The comments in this submission demonstrate that the applicant has not provided sufficient evidence to confirm that their proposals meet the requirements of the NFCC (National Fire Chiefs Council) Guidance for Grid Scale BESS (Battery Energy Storage Systems). The proposals should meet the NFCC guidance, to ensure that sufficient BESS fire risk control/mitigation measures have been implemented, to consider the residual risk to be as low as is reasonably practicable.

Project Name  
 Peartree Hill Solar Farm

Drawing No.  
 Environmental Statement Volume 3, Figure 3.1: Indicative Operational Layout Plan

## Dispersion Calculation for BESS Container Release of Hydrogen Fluoride

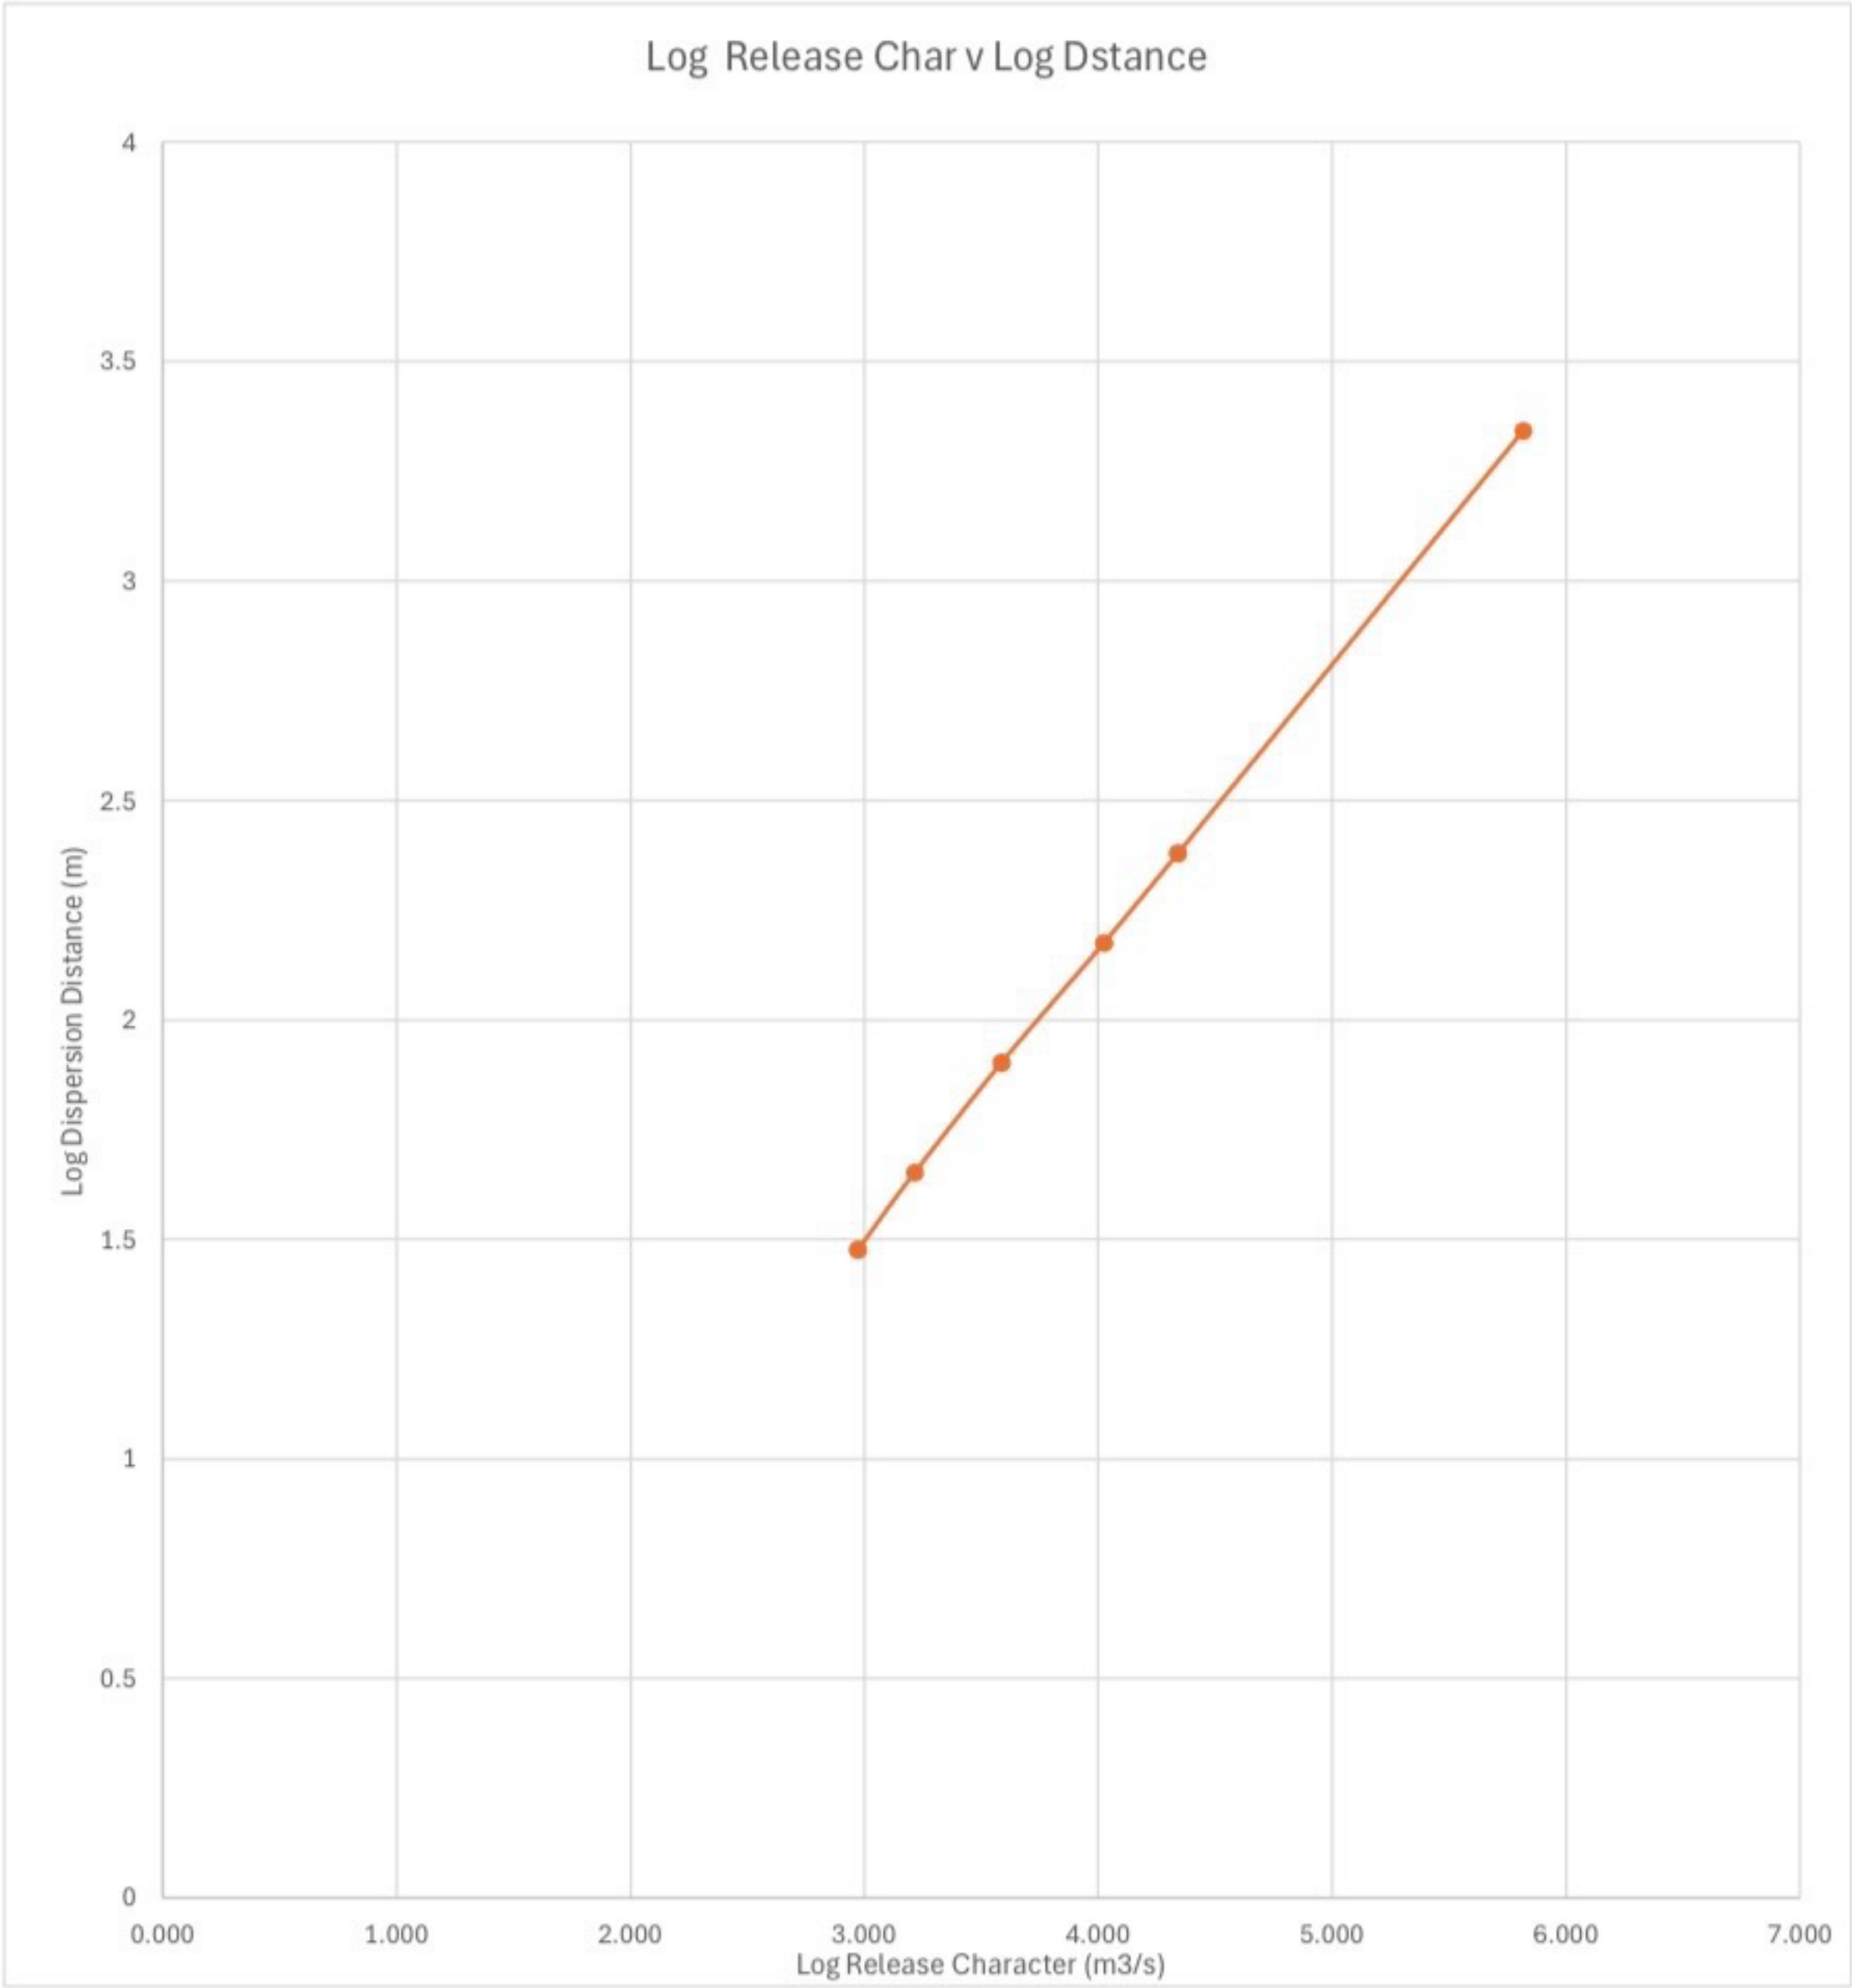
Based on dispersion modelling carried out by Atkins for HSENI presented in Table 6.1 for dispersion conditions D5:-  
[EN010106-003806-DL2 - \[REDACTED\] - Appendix 6 \(2 of 2\) - Academic Reports.pdf](#)

Estimate of dispersion distance for Hydrogen Fluoride concentration to 1 ppm via the methology in BS60079 Part 10

Release Character (RC) = Discharge Rate Wg (Kg/s) / (Desity (Kg/m3) x Concentration (Vol/Vol))

Wg (Kg/s)	ppm	Concentration	Release Char	Log RC	Log Distance	Distance (m)
0.556	700	0.0007	936.2	2.971	1.4771	30
0.556	400	0.0004	1638.3	3.214	1.6532	45
0.556	170	0.00017	3854.9	3.586	1.9031	80
0.556	62	0.000062	10569.8	4.024	2.1761	150
0.556	30	0.00003	21844.3	4.339	2.3802	240
0.556	1	0.000001	655328.8	5.816	3.3424	2200

# REP5-023

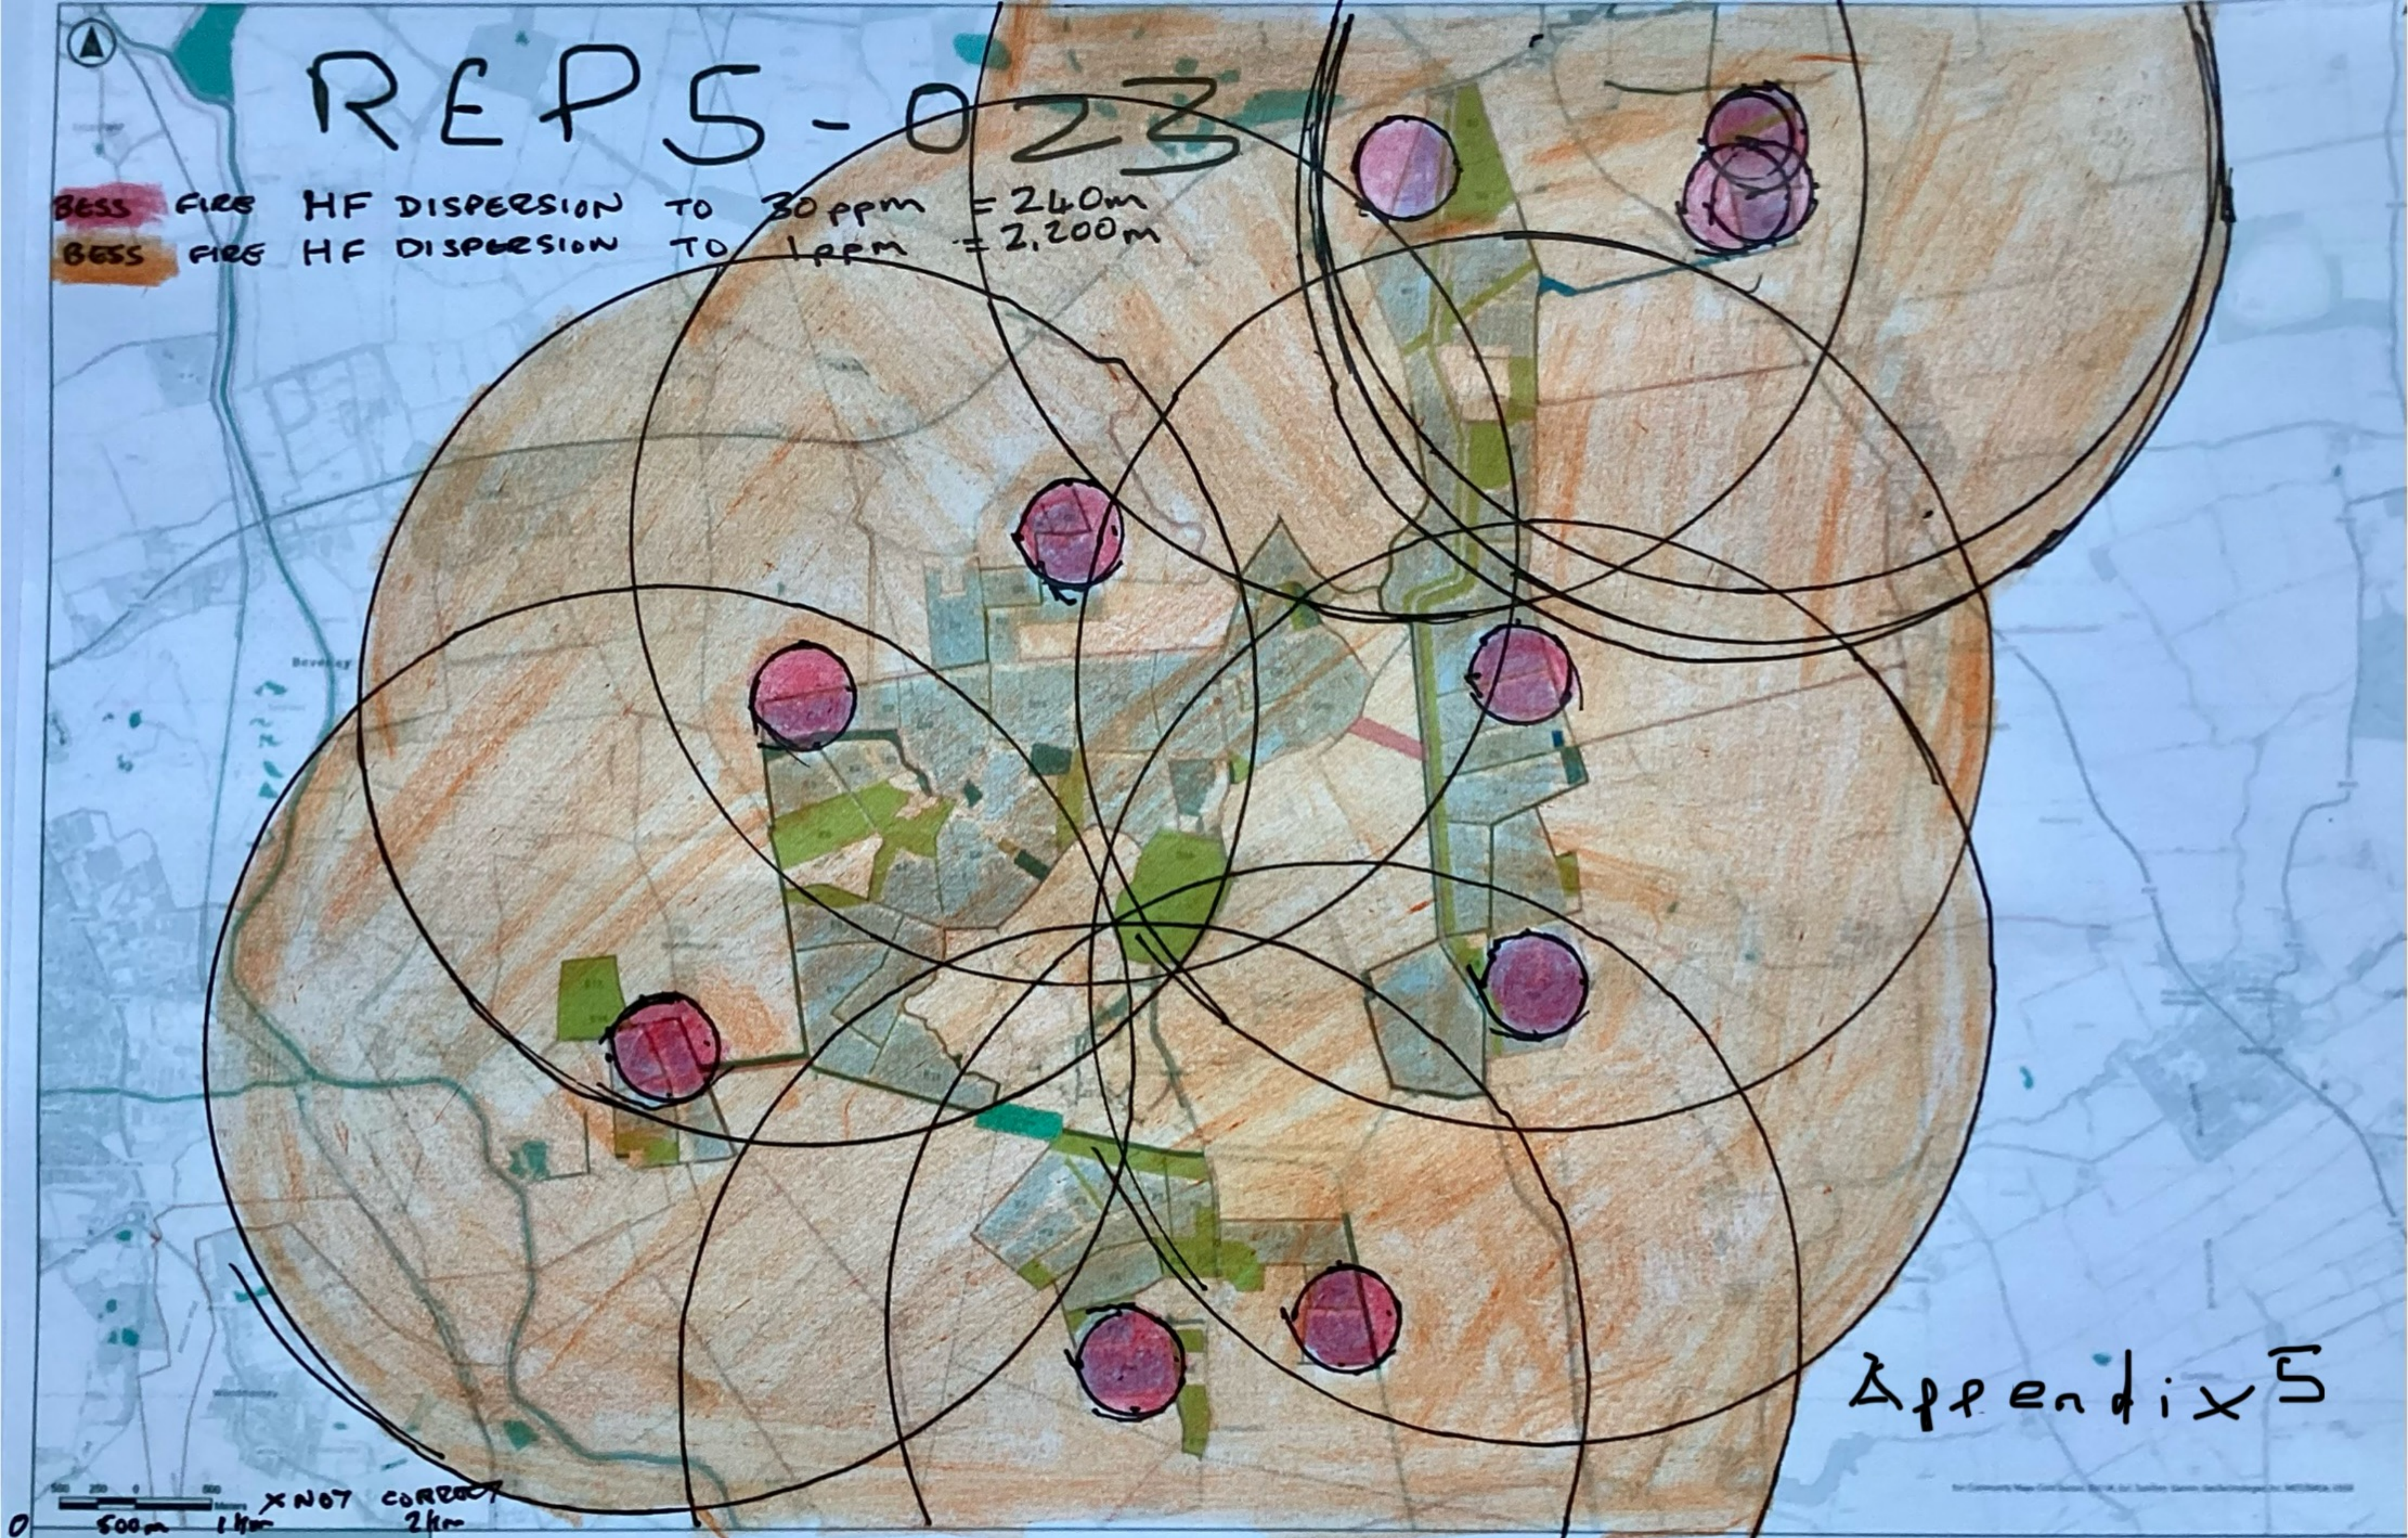
I request that the Planning Inspectorate consider whether the potential catastrophic risk impacts from BESS thermal runaway have been adequately controlled in this application. The applicant has proposed that the 84 BESS sites are distributed over a large area of East Yorkshire. In the event of a cyber attack, resulting in several BESS containers going into thermal runaway, then Holderness and Hull could be impacted (see map in A5).

The BESS containers are proposed to be located in fields, as shown in drawing REP5-023, which are not near any existing street fire hydrants. The applicant has not included suitable fire water tanks or hydrant systems to cool adjacent BESS containers, as required in the NFCC guidance:-

The proposed BESS locations are in flood zones. The applicant has not provided 2 suitable alternative emergency access points or considered flood mitigation access measures, as shown in drawing REP5-023, which does not meet the NFCC guidance:-

BESS FIRE HF DISPERSION TO 30ppm = 240m  
 BESS FIRE HF DISPERSION TO 1ppm = 2,200m

500m 1km 2km  
 X NOT CORRECT
